DATE: 9-30-2011

The following are additional comments relative to OIR-B1-1802

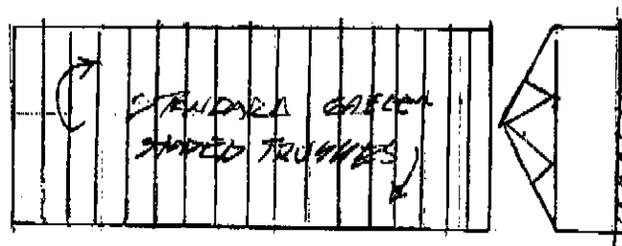
Insurers must be compensated for proven risk. Equally important, however, in light of the current financial conditions, homeowners may lack means and methods to meet increased premiums and which has not been addressed and requires further study. One of the largest factors affecting the premium for example is the determination of the geometry of the roof. Section 5 of the check list is to indicate if the roof geometry is a hip roof or a gable roof.

While geometry is the focus, the framing seems to be ignored. While there may be other methods of roof framing in residential construction, the two most common methods of framing are with proprietary metal plate connected wood trusses (MPCWT) or conventional framing with roof rafters and ceiling joists.

MPCWT behavior when correctly designed erected and installed is by far the more effective roof protection than conventionally framed roofs. While roof slope has been a variable reported as well as roof geometry in general, no distinction appears to have been made to the unique differences between the two types of construction.
